# Access Compliance Report

## Public Rights-of-Way

### (Curb Ramps)

Intersection ID: 47162	Main Street: SHARON_RD	Cross Street: SHARON_TOWNSHIP_LN	Location: NW
ADA ID: D441A4E1A41A	Ramp Type: PerpDiag	Initial Pass/Fail: Fail	Overall Compliance: No
Severity Score: 12.5			
Codes/Mitigation Info/Possible Solution		Field Measurements/Component Compliance

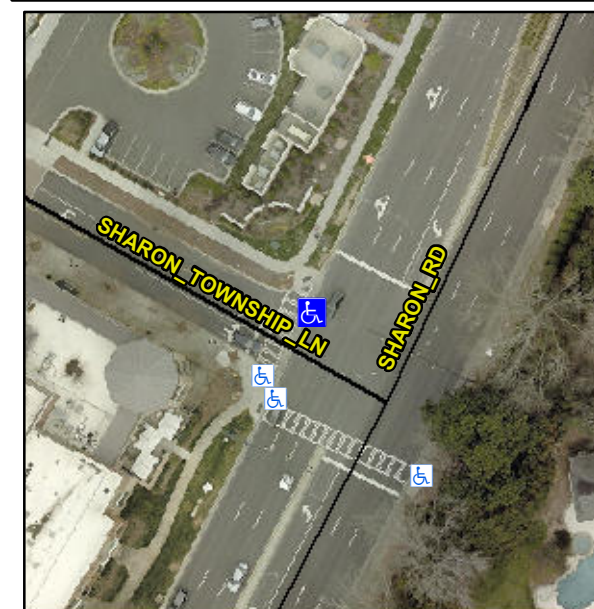
**Not Found, R304.2.2**

Compliance	Description	Data	Compliance	Description	Data
N/A	Ramp Length (in)	96.0	No	Ramp Slope (%)	8.9
Yes	Ramp Width (in)	60.0	Yes	Ramp XSlope (%)	0.7
N/A	Flare Type LT	N/A	N/A	Flare Type RT	N/A
N/A	Flare Slope LT (%)	N/A	N/A	Flare Slope RT (%)	N/A
N/A	Flare Traversable LT?	N/A	N/A	Flare Traversable RT?	N/A
N/A	Landing Length (in)	N/A	N/A	DWS Provided?	N/A
N/A	Landing Width (in)	N/A	N/A	DWS Contrast?	N/A
N/A	Landing Slope (%)	N/A	N/A	DWS Length (in)	N/A
N/A	Landing X Slope (%)	N/A	N/A	DWS Full Width?	N/A
N/A	Landing Curb? (Y/N)	N/A	N/A	DWS Offset (in)	N/A
N/A	Shared Landing?	N/A			
N/A	Gutter Ponding?	N/A	N/A	Gutter Slope (%)	N/A
N/A	Gutter Lip Ht (in)	N/A	N/A	Gutter X Slope (%)	N/A
N/A	Painted X Walk1?	Yes	N/A	Painted X Walk2?	No
	X Walk 1 Direction	To SW		X Walk 2 Direction	To SE
N/A	X Walk 1 Width (in)	110.0	N/A	X Walk 2 Width (in)	N/A
	X Walk 1 Slope (%)	1.6		X Walk 2 Slope (%)	1.9
	X Walk 1 X Slope (%)	4.3		X Walk 2 X Slope (%)	1.6

**Remove & Replace Curb Ramp With Two New Directional Ramps or Equivalent.**
